**Product Safety Warning
- Updated Information**

Total Solutions & Power (TSP) accumulators

SL2016-616/PRP
May 2016

Fig. 1: TSP accumulator

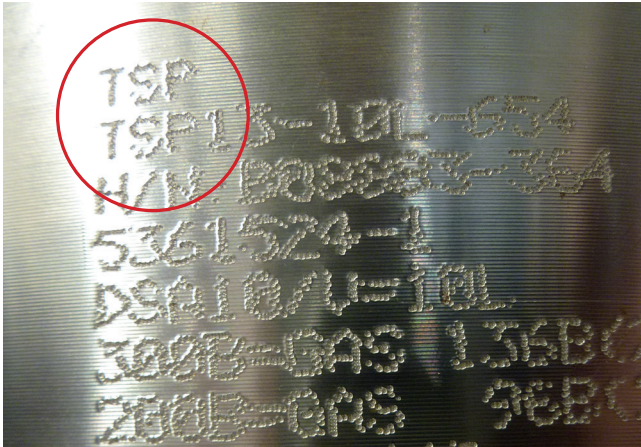
The TSP accumulator can be identified as shown in Fig. 1.

Fig. 2: 10L accumulators produced in 2013

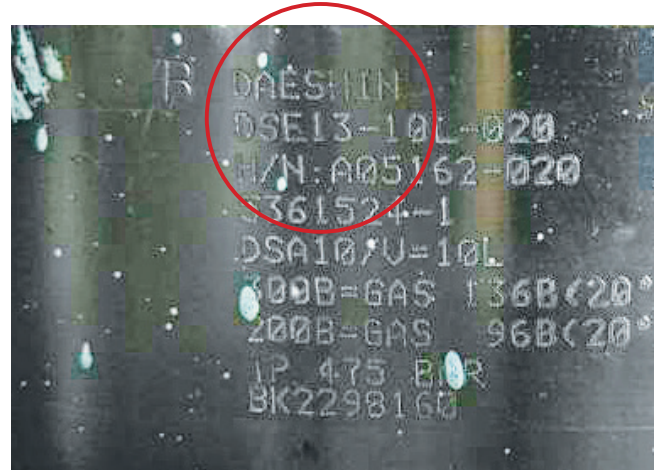
TSP produced 10L accumulators in 2013 which are marked Daeshin, see Fig. 2. These must also be exchanged.
